Project 86-060-24
December 1990

Response to Comments and Proposed Reclamation Plan Modifications

Church Rock Site
Gallup, New Mexico

United Nuclear Corporation
Gallup, New Mexico

DATE: 11-12-90	FIGURE 2-9	DRAWING NUMBER 86-060-B423
SCALE: AS SHOWN

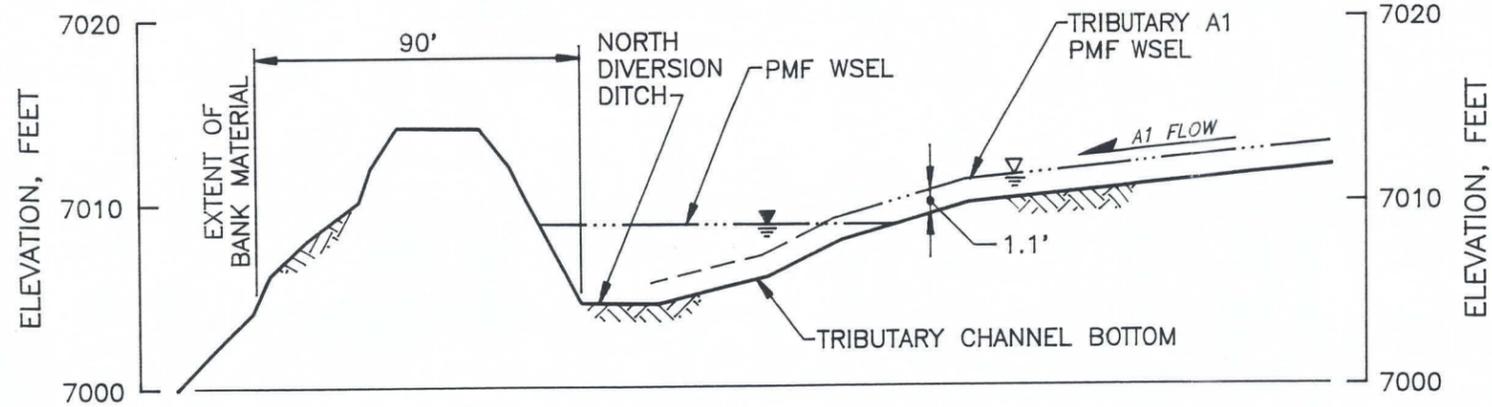
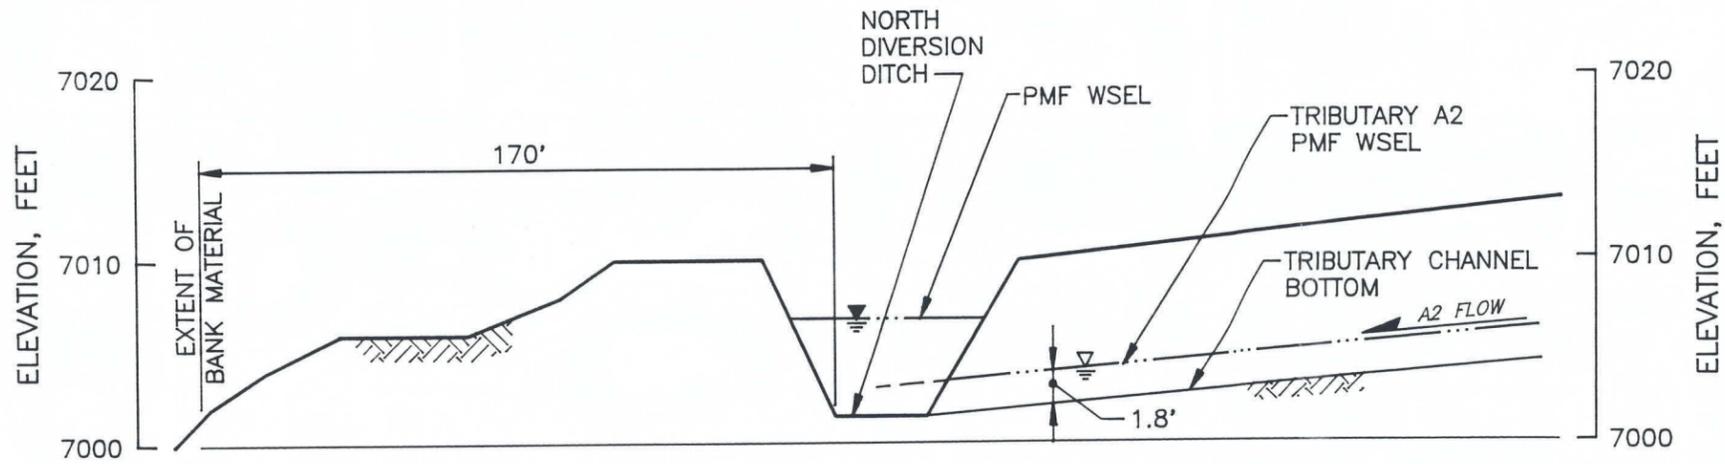
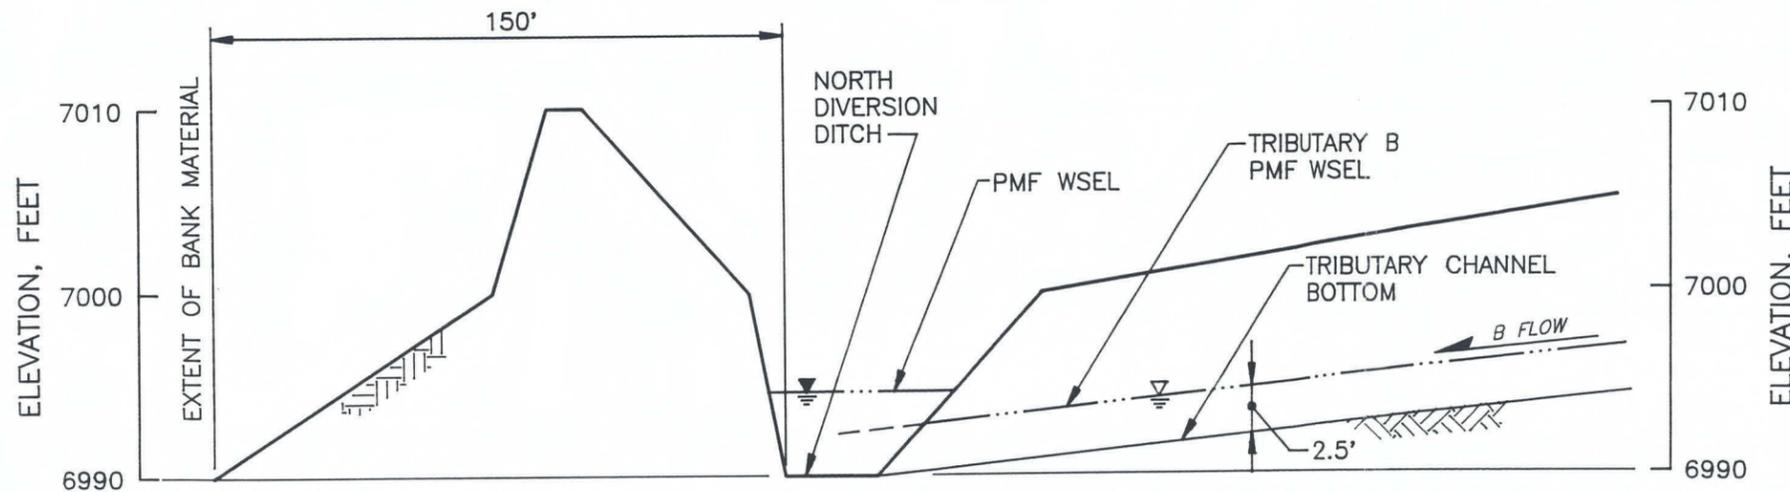
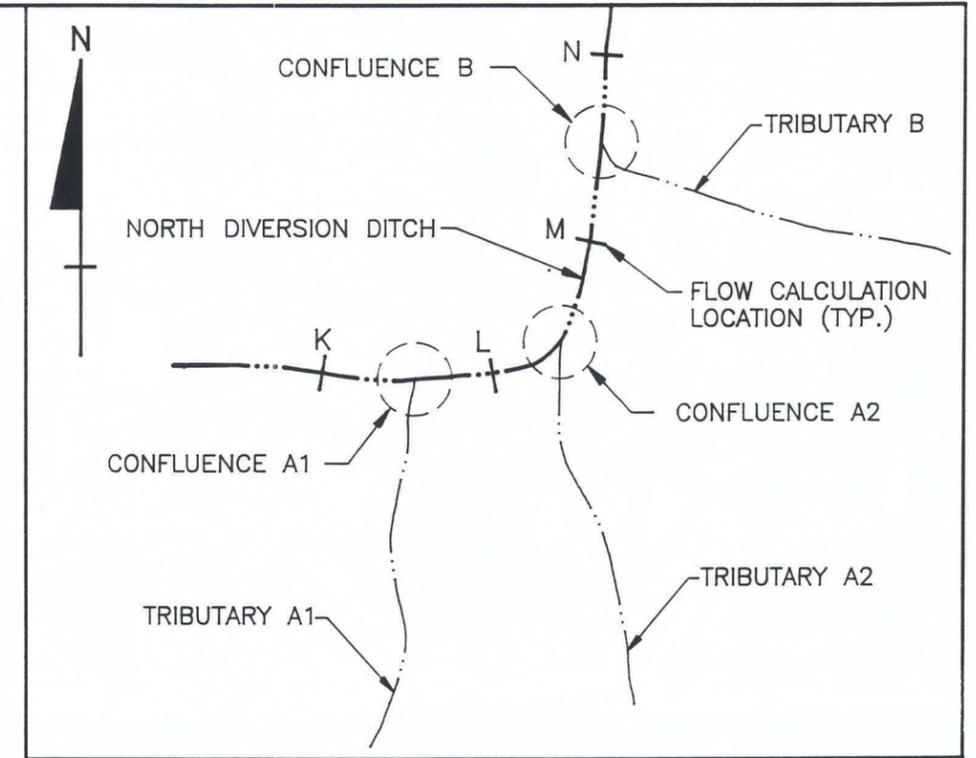
Figure 2-9 provides a schematic of the tributaries and related cross sections on the North Diversion Ditch. Table 2.8 provides a summary of PMF flow characteristics for each of these locations. The PMF peak discharges were determined using the SCS TR55 method. Manning's equation was used to

Figure 2-9 provides cross sections of the North Diversion Ditch at the confluences. The cross sections show the extent of material that would have to be scoured before flows left the diversion ditch and passed across the tailings. These scour distances are 90 feet at confluence A1, 170 feet at confluence A2, and 150 feet at Tributary B. These distances are all sufficiently large such that channel scour would not allow flows to pass over the tailings. In addition, as channel scour removes material from the far bank during a particular flow event, the channel would become wider and thus protect itself from future scour.

At confluence A1, the total head of the tributary flow is considerably less than that of flow in the ditch. Furthermore, channel scour would have to remove 90 feet of material before flows could pass onto the tailings. At
